Introduction - the Barossa gas to Darwin LNG project

This referral clarifies some points of uncertainty about what Santos is intending to do with the Barossa gas to Darwin LNG project.

Introduction – the Barossa gas to Darwin LNG project

Figure 1 – The Barossa to Darwin LNG development – a simplified flowscheme

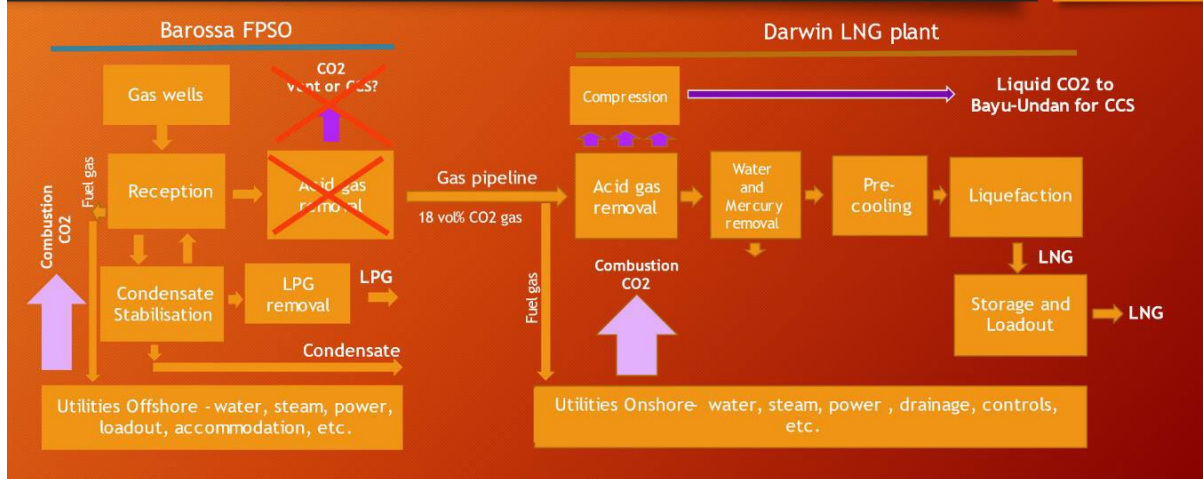
Emissions from the Modified Barossa gas to Darwin LNG project

- Deduced from Santos statements- Scenario D?

Adding CCS to the Barossa development in the way Santos appears to favour would bring little or no reduction in emissions, while adding substantial cost, delays and risk.

If it is still to be considered for approval, this project should be required - by the relevant authorities - to build the CCS-enabling facilities no later than the gas production facilities and to prove their satisfactory operation before any export of LNG cargoes are permitted. A repeat of the Gorgon CCS debacle in Western Australia is just not acceptable.
